Access Compliance Report Public Rights-of-Way (Curb Ramps)

Intersection ID: 25072
 Main Street:
 CARRIAGE_LAKE_DR
 Cross Street:
 COPPER_RIDGE_TL
 Location:
 SW

ADA ID: BADF3F595C79
 Ramp Type:
 Perp
 Initial Pass/Fail:
 Fail
 Overall Compliance:
 No
 Severity Score:
 37.5

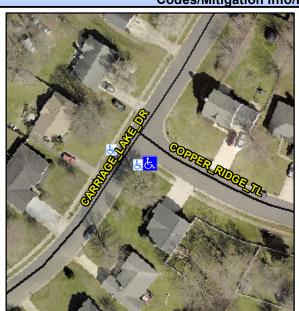
Not Found, R304.2.2, R304.5.3

Field Measurements/Component Compnance					
Compliance Description Date		Data	Compliance Description		Data
N/A	Ramp Length (in)	101.0	No	Ramp Slope (%)	10.6
Yes	Ramp Width (in)	48.0	No	Ramp XSlope (%)	7.8
N/A	Flare Type LT	N/A	N/A	Flare Type RT	N/A
N/A	Flare Slope LT (%)	N/A	N/A	Flare Slope RT (%)	N/A
N/A	Flare Traversable LT?	N/A	N/A	Flare Traversable RT?	N/A
N/A	Landing Length (in)	N/A	N/A	DWS Provided?	N/A
N/A	Landing Width (in)	N/A	N/A	DWS Contrast?	N/A
N/A	Landing Slope (%)	N/A	N/A	DWS Length (in)	N/A
N/A	Landing X Slope (%)	N/A	N/A	DWS Full Width?	N/A
N/A	Landing Curb? (Y/N)	N/A	N/A	DWS Offset (in)	N/A
N/A	Shared Landing?	N/A			
N/A	Gutter Ponding?	N/A	N/A	Gutter Slope (%)	N/A
N/A	Gutter Lip Ht (in)	N/A	N/A	Gutter X Slope (%)	N/A
N/A	Painted X Walk1?	No	N/A	Painted X Walk2?	N/A
	X Walk 1 Direction	To NE		X Walk 2 Direction	N/A
N/A	X Walk 1 Width (in)	N/A	N/A	X Walk 2 Width (in)	N/A
	X Walk 1 Slope (%)	1.8		X Walk 2 Slope (%)	N/A

Remove & Replace Entire Ramp.
